Access Compliance Report

Public Rights-of-Way

(Curb Ramps)

Intersection ID: 42363	Main Street: CONDOR_CR	Cross Street: KESTRAL_RIDGE_DR	Location: NW
ADA ID: E58D459F2379	Ramp Type: BlendTrans1	Initial Pass/Fail: Pass	Overall Compliance: No
			Severity Score: 10.25

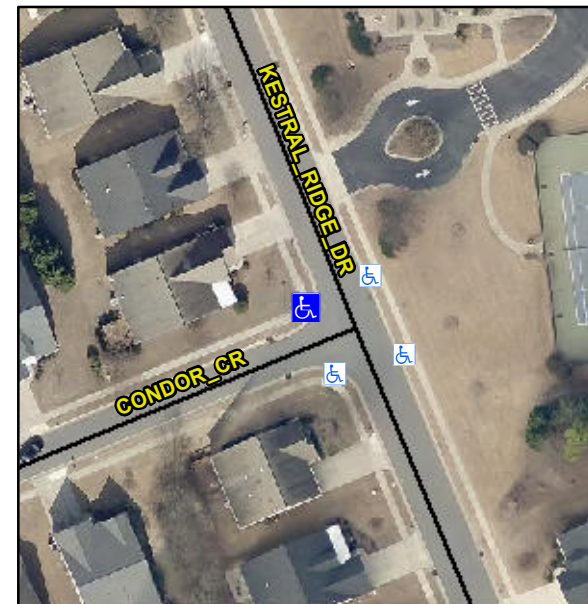
Not Found, R304.5.3, R304.2.2-Perp, R304.3.2-Para, R305

Compliance	Description	Data	Compliance	Description	Data
N/A	Ramp Length (in)	46.0	Yes	BlendTrans Slope (%)	1.3
Yes	Ramp Width (in)	73.0	No	BlendTrans XSlope (%)	2.6
N/A	Flare Type LT	Sloped	N/A	Flare Type RT	Sloped
N/A	Flare Slope LT (%)	2.0	N/A	Flare Slope RT (%)	5.1
N/A	Flare Traversable LT?	No	N/A	Flare Traversable RT?	No
Yes	Landing Length (in)	55.0	No	DWS Provided?	No
Yes	Landing Width (in)	68.0	N/A	DWS Contrast?	No
No	Landing Slope (%)	7.7	N/A	DWS Length (in)	N/A
No	Landing X Slope (%)	2.6	N/A	DWS Full Width?	No
N/A	Landing Curb? (Y/N)	No	N/A	DWS Offset (in)	N/A
N/A	Shared Landing?	No			
Yes	Gutter Ponding?	No	Yes	Gutter Slope (%)	4.0
Yes	Gutter Lip Ht (in)	0.0	No	Gutter X Slope (%)	3.0
N/A	Painted X Walk1?	No	N/A	Painted X Walk2?	No
	X Walk 1 Direction	To S		X Walk 2 Direction	To E
	X Walk 1 Width (in)	N/A		X Walk 2 Width (in)	N/A
	X Walk 1 Slope (%)	1.4		X Walk 2 Slope (%)	2.6
	X Walk 1 X Slope (%)	1.8		X Walk 2 X Slope (%)	2.3

N/A	Ramp inside XWalk1?	N/A	N/A	Ramp inside XWalk2?	N/A
	Road Slope (%)	3.0		Clear Space?	Yes
	Road X Slope (%)	1.0	N/A	Clear Space to XWalk (in)	N/A
Yes	Any Obstructions?	No	Yes	Storm Grate/Utility Hazard?	No
	Obstruction Type			Storm Grate/Utility Type	
		N/A			N/A
			Yes	Surface Condition? (G/P)	Good
			No	Curb Slope (%)	5.4

Remove & Replace Curb Ramp With Two New Directional Ramps or Equivalent. Remove & Replace Gutter.
